SERVICE BULLETIN

APPLICABILITY: 2014MY and Later STI Models
SUBJECT: Design Change to Reverse Idler Gear Components

NUMBER: 03-73-14
DATE: 03/10/14

COUNTERMEASURE IN PRODUCTION

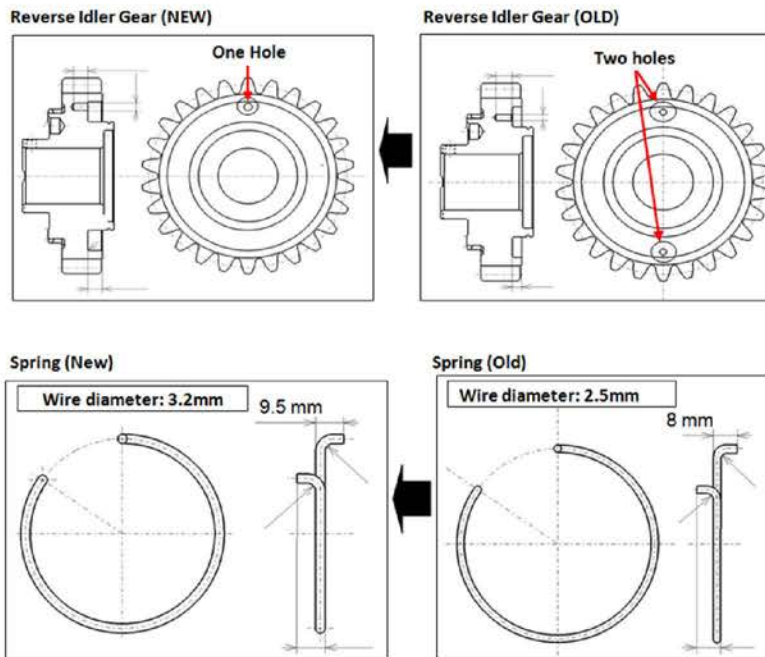
This bulletin informs of a design change to the reverse idler gear and its internal spring along with a revised assembly procedure. The only purpose for the change was to enhance production efficiency.

The new reverse idler components were incorporated into production during mid-October, 2013 starting with **VIN E*224413**.

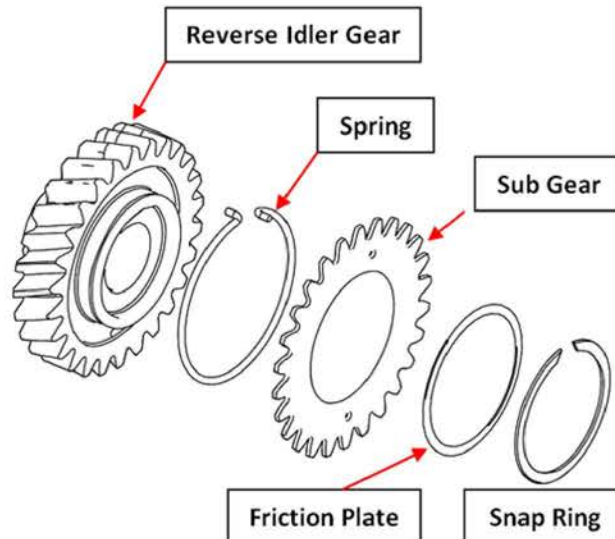
IMPORTANT: The revised parts listed in the table below **must always be replaced as a set**.

The illustrations below provide a reference for identifying differences between the old and new parts.

PART NAME	NEW PART NUMBER
GEAR-REV IDLER	32282AA210
SPRING-REV IDLER	32369AA040
